DART SERVICE INSTRUCTION

TO AMEND INSTALLATION INSTRUCTIONS IN D412-742 REV. E AND
INSTRUCTIONS FOR CONTINUED AIRWORTHINESS ICA-D412-742 REV. 4

REF FAA STC: SR01583SE
REF CANADIAN STC: SH05-37
REF EASA STC: EASA.IM.R.S.00126

A	NEW ISSUE	WM	15.11.27
REV.	DESCRIPTION	BY	DATE
DESIGN	AP	DART AEROSPACE USA, INC EUGENE, OR	
DRAWN	WM		
CHECKED	ASS	DRAWING NO.	REV. A
MFG. APPR.	NIA	DSI 9733	SHEET 1 OF 3
APPROVED	en	TITLE	SCALE
DE APPR.	en	SKIDTUBE INSERT REPAIR	NTS
DATE	15.11.27	COPYRIGHT © 2015 BY DART AEROSPACE USA, INC THIS DOCUMENT IS PRIVATE AND CONFIDENTIAL AND IS SUPPLIED ON THE EXPRESS CONDITION THAT IT IS NOT TO BE USED FOR ANY PURPOSE OR COPIED OR COMMUNICATED TO ANY OTHER PERSON WITHOUT WRITTEN PERMISSION FROM DART AEROSPACE USA, INC.

FIGURE 1 - AFFECTED LOCATIONS
(Aft section of D412-742-XXX Assy shown)

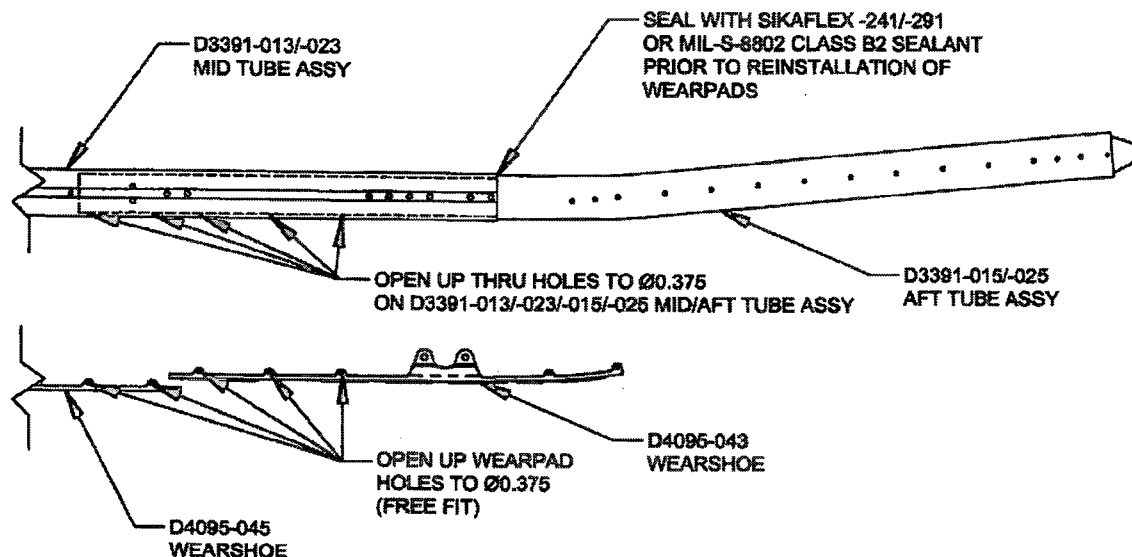
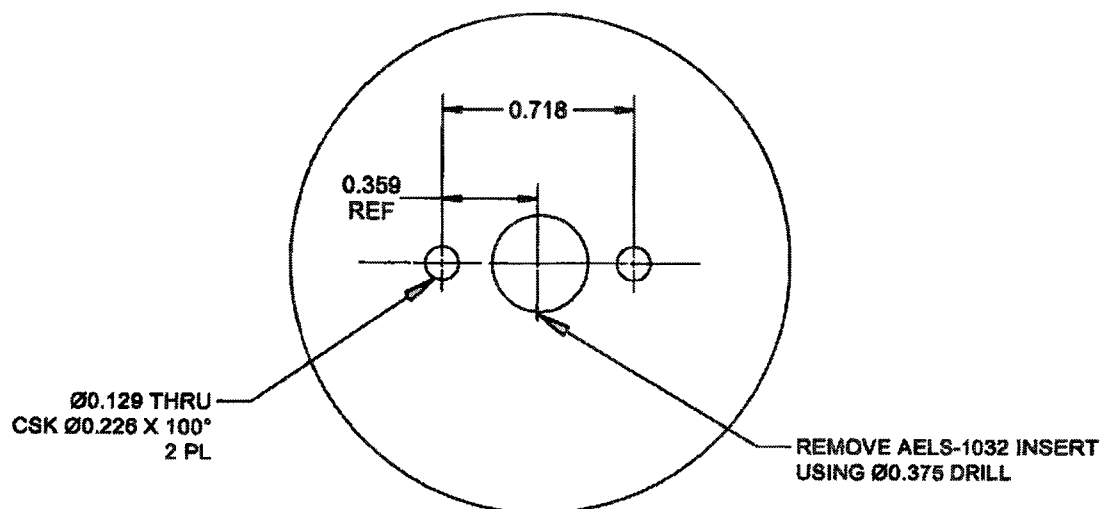
The purpose of this DART Service Instruction is to provide a repair procedure to replace spinning AELS-1032 inserts with MS21075L5 Floating Nut Plates on D412-742-011/-013 Float Skid tubes in locations where the D3391-013/-023 Mid Tube Assembly overlaps the D3391-015/-025 Aft Tube Assembly as shown in Figure 1.

- 2.1 Drill out AELS-1032 Inserts (Qty 10) located in D3391-015/-025 Aft Tube Assembly using a $\varnothing 0.375$ drill in locations shown in Figure 1. With reference to Note 2, add additional $\varnothing 0.129$ countersunk holes (Qty 2) per Detail A.

- 2.2 Increase the diameter of affected thru holes in D3391-013/-023 Mid Tube Assembly with a $\varnothing 0.375$ drill bit, as shown in Figure 1.
- 2.3 Touch up affected areas with chemical film material (Alodine 1200 or 1201) per MIL-C-5541.

- 2.4 Install MS21075L5 Nut Plate (Qty 10) using MS20601AD4W4 (Qty 12) in the six (6) most forward holes and MS20601AD4W9 (Qty 8) in the four (4) aft holes. It is acceptable to replace MS20601AD4 rivets with longer or shorter rivets as required.
